**SUBJECT: The Sod Guy
Sales Lot
Drainage Letter – Lot 1 in Appaloosa Highway 24 Subdivision Filing No 1A**

PCD FILE NO. PPR1925

DATE	REVISIONS
----	----
----	----
----	----
----	----
----	----
----	----
----	----
----	----
----	----
----	----

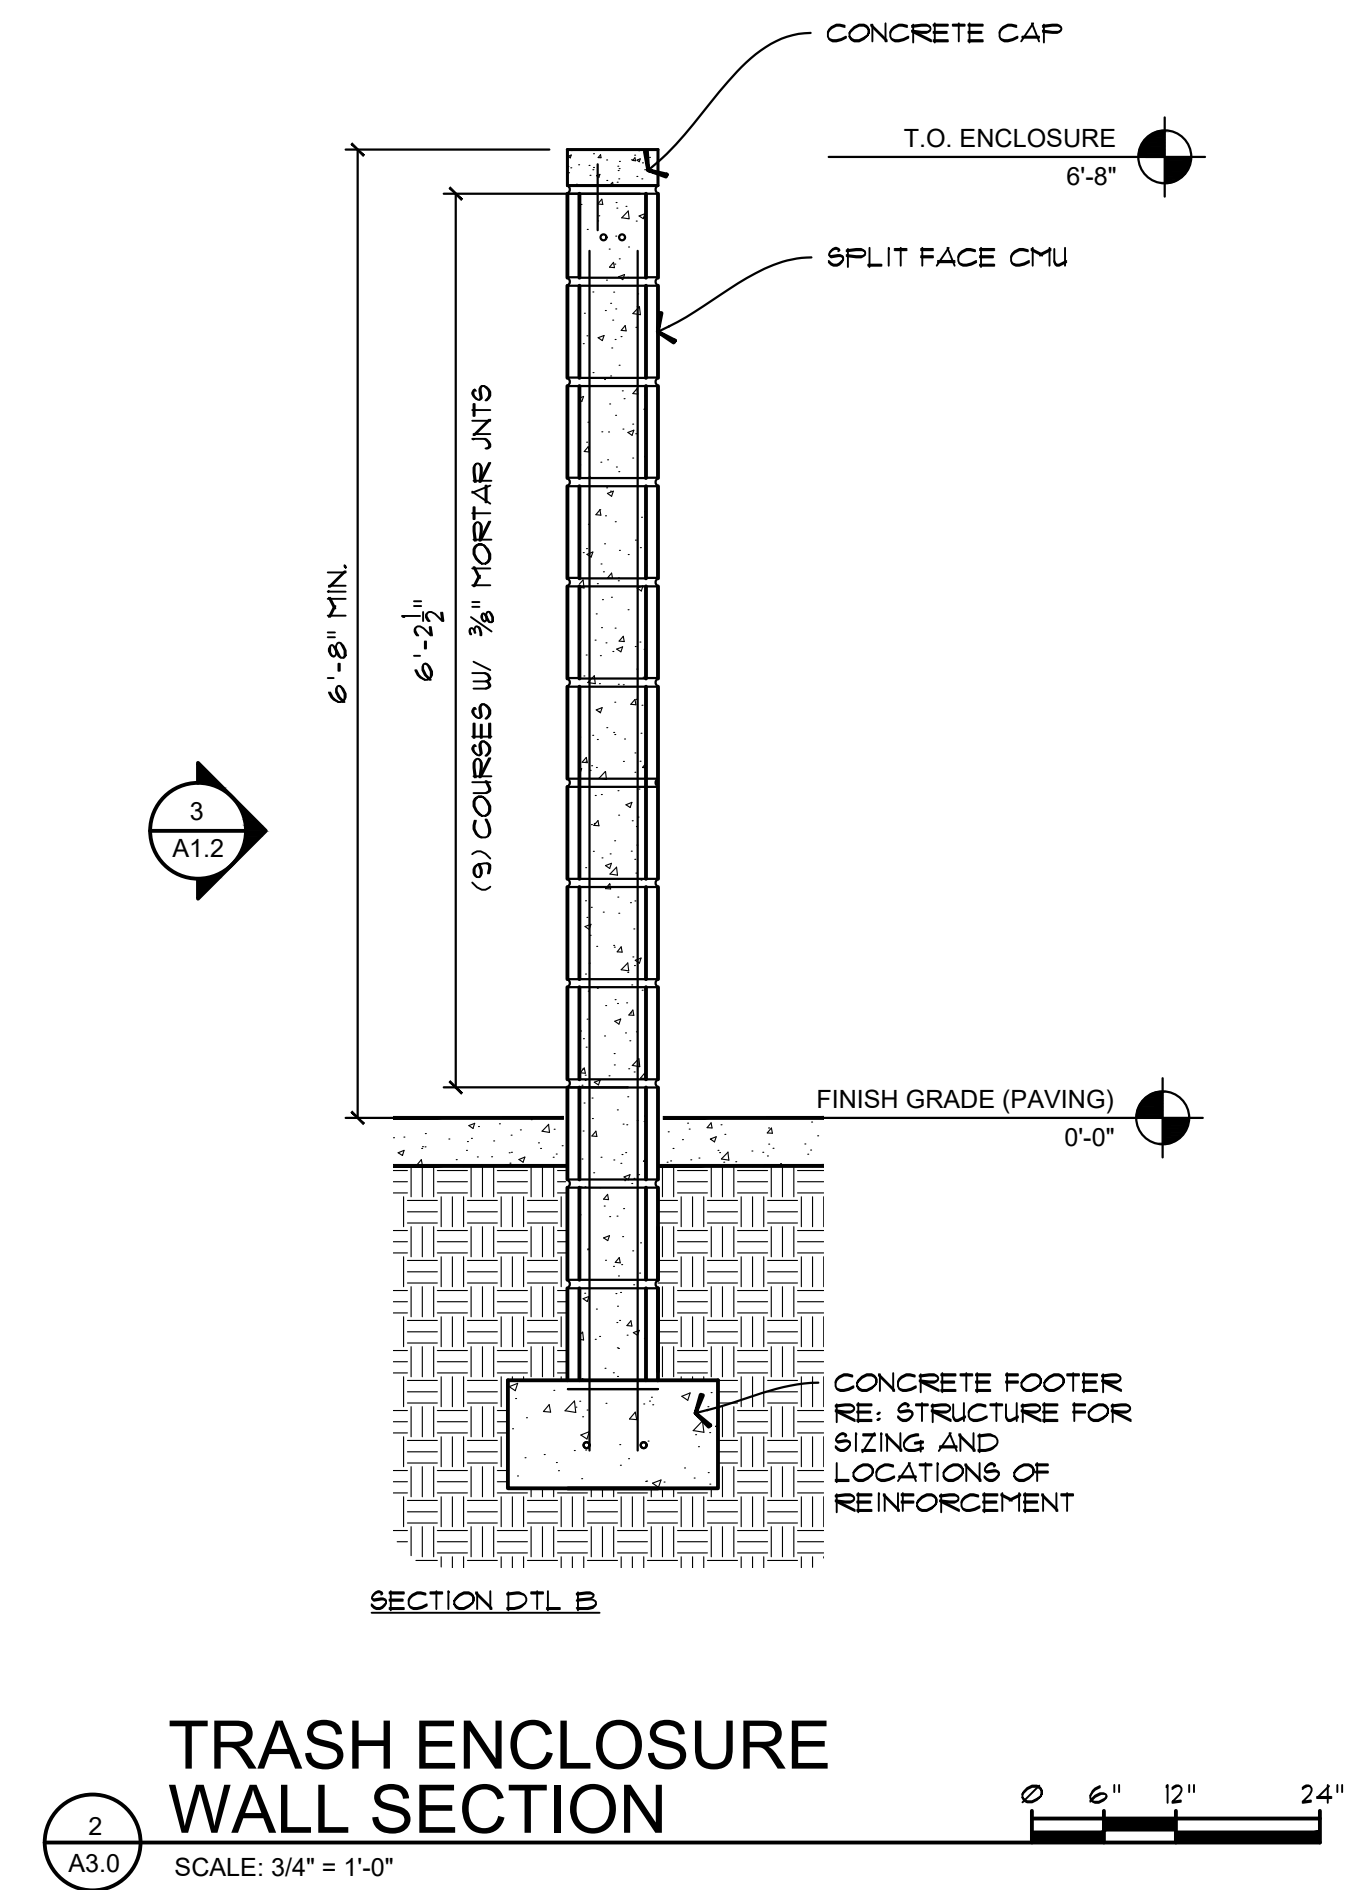
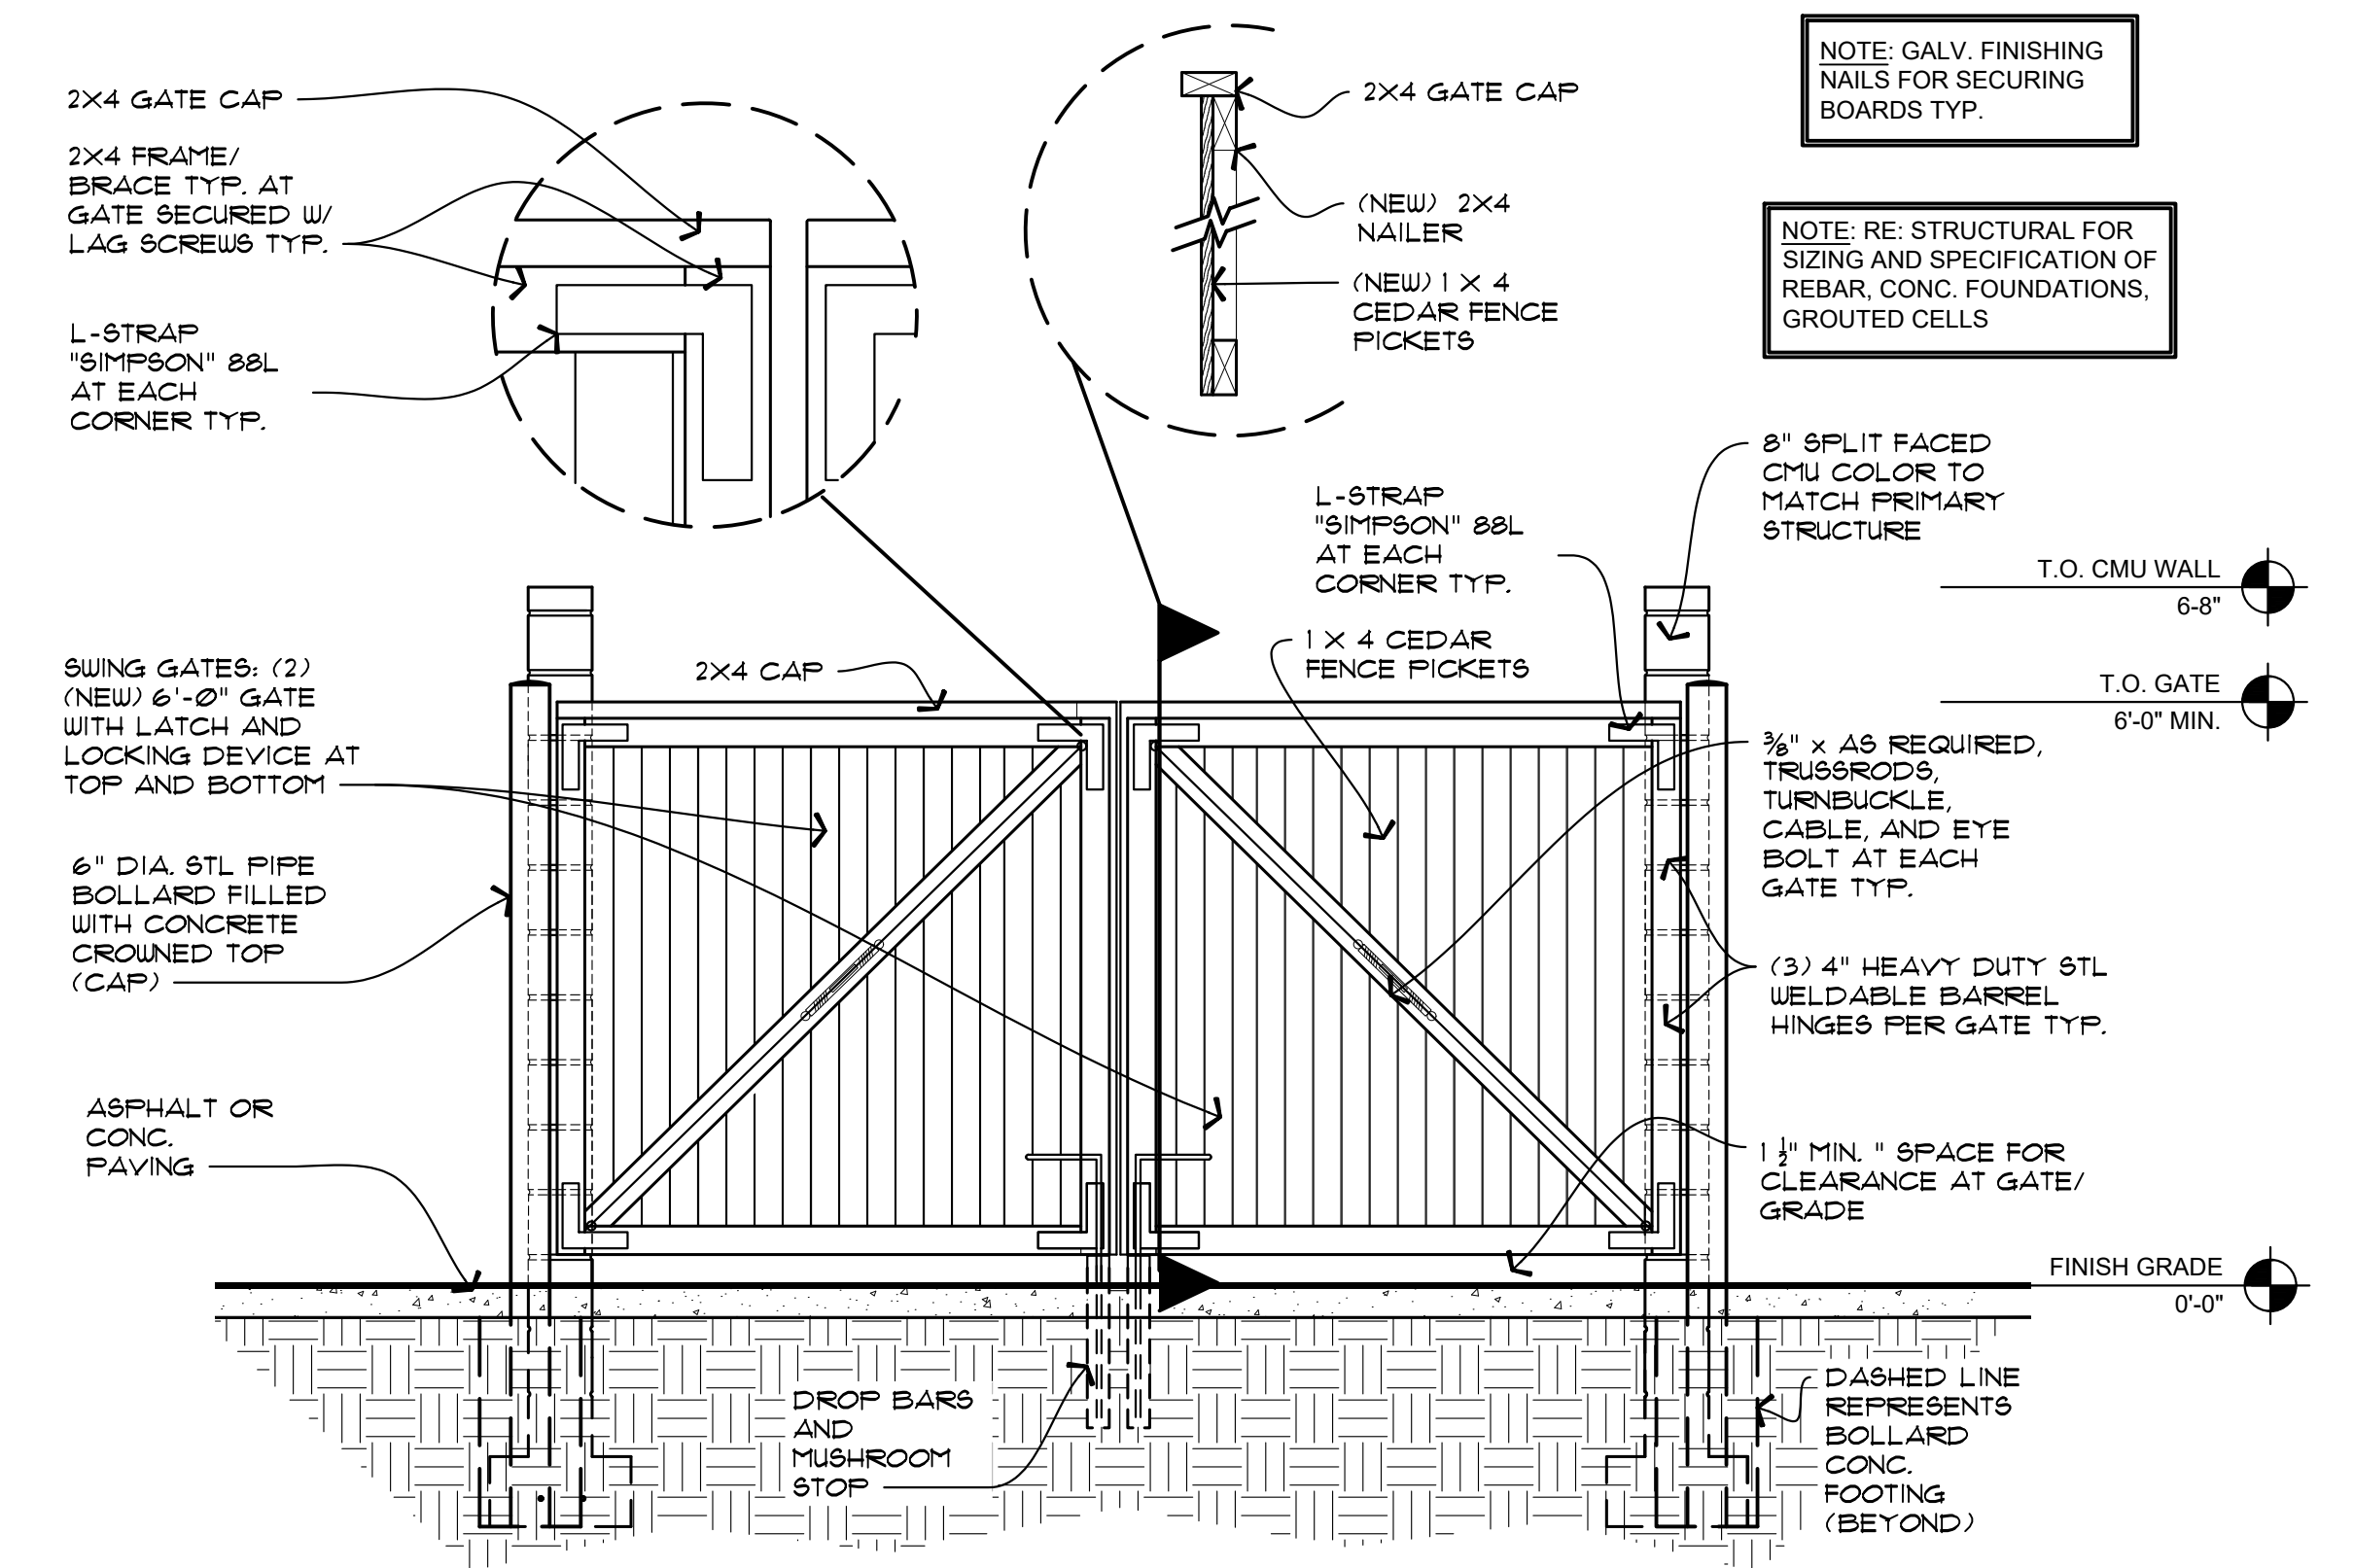
Remove this sheet from the drainage letter

TRASH ENCLOSURE ELEVATION
 SCALE: 1/2" = 1'-0"
 0" 1" 2" 4"

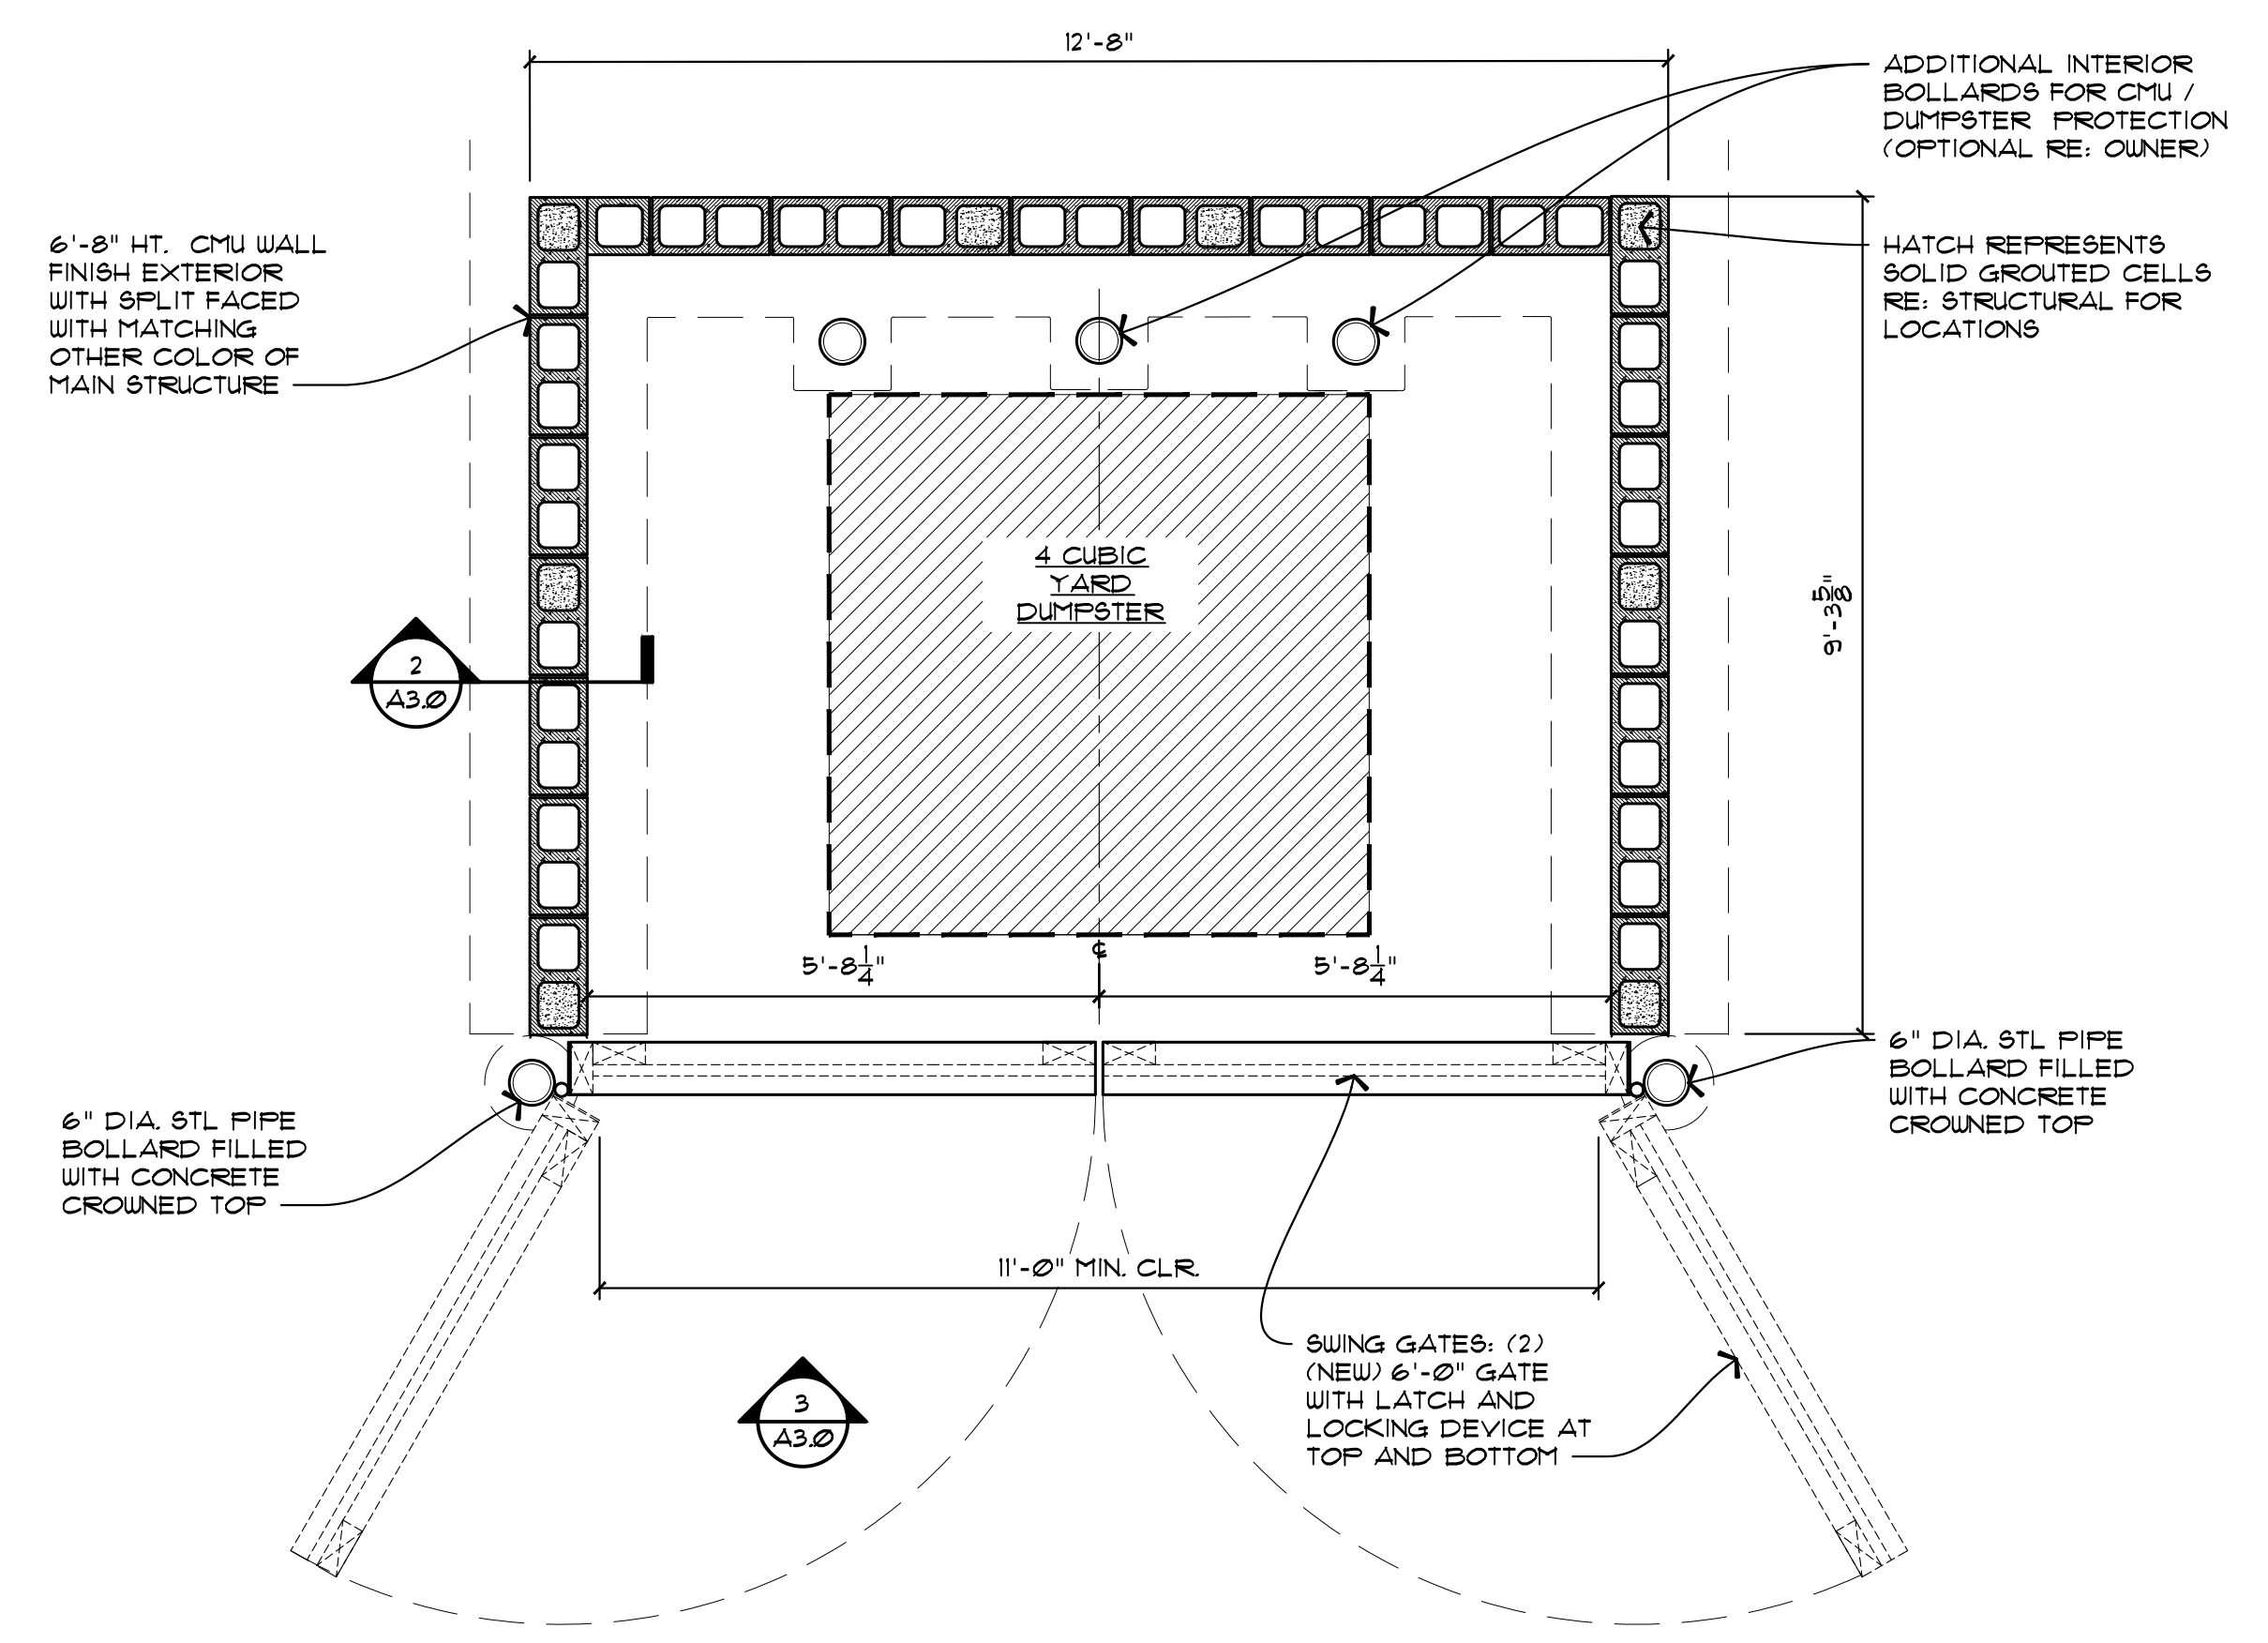
Remove this sheet from the drainage letter
